Process Change Notification

PCN Reference: 558-PCN30-Public

Correction of Package Outline Drawing (POD) to current dimensions.

PQFN 5x6 Outline "E" Package Details

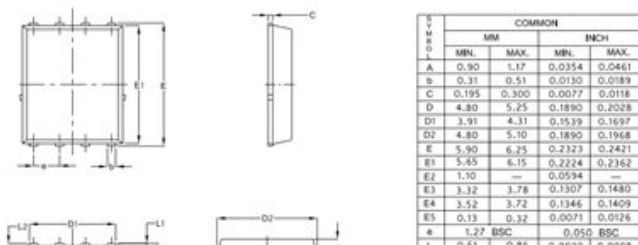
The data sheet was released with option E POD, instead it should be release with Option G.

This PCN is to correct the POD in the data sheet.

PQFN 5x6 Outline "G" Package Details

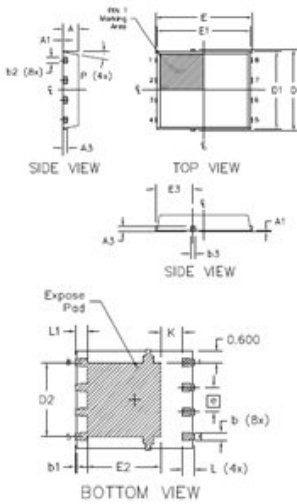
After
Revised Package Outline Drawing in product datasheet (POD):

5x6mm Option E vs G Critical Dimensions Comparison										
Description	Dimension	GTBF (Option E)			ASEWH (Option G)			JEDEC MO-240C (REFERENCE)		
		MIN	NOM	MAX	MIN	NOM	MAX	MIN	NOM	MAX
Pkg Thk (Z)	A	0.900		1.170	0.950		1.050	0.900	1.050	1.200
Exces LF outside pkg perimeter (Z)	A1	0.000		0.050	0.000		0.050	0.000	N/A	0.050
LF cross section inside dimension (Z)	A3	0.195		0.300	0.254 BSC			0.230	0.280	0.330
Lead Width (X)	b	0.330		0.510	0.310		0.510	0.330	0.410	0.510
Pkg Length (X)	D	4.800		5.150	5.15 BSC			5.15 BSC		
Bottom Mold Cap Length (X)	D1	4.800		5.000	5.00 BSC			4.500	4.900	5.100
Expose pad length (X)	D2	3.700		4.310	3.700		3.900		N/A	4.220
Pkg width (Y)	E	5.900		6.150	6.15 BSC			6.15 BSC		
Bottom Mold Cap width (Y)	E1	5.650		6.000	6.00 BSC			5.500	5.800	6.100
Expose pad width (Y)	E2	3.320		3.780	3.560		3.760		N/A	4.300
Lead Pitch	e	1.27 BSC			1.27 BSC			1.27 BSC		
Lead Length	L	0.510		0.860	0.510		0.710	0.510	0.610	0.710

LF length attached to the pad dimension	L1	0.380		0.710	0.510		0.710	0.510		0.710
Pkg Body Chamfer degrees	P			12	10		12			12
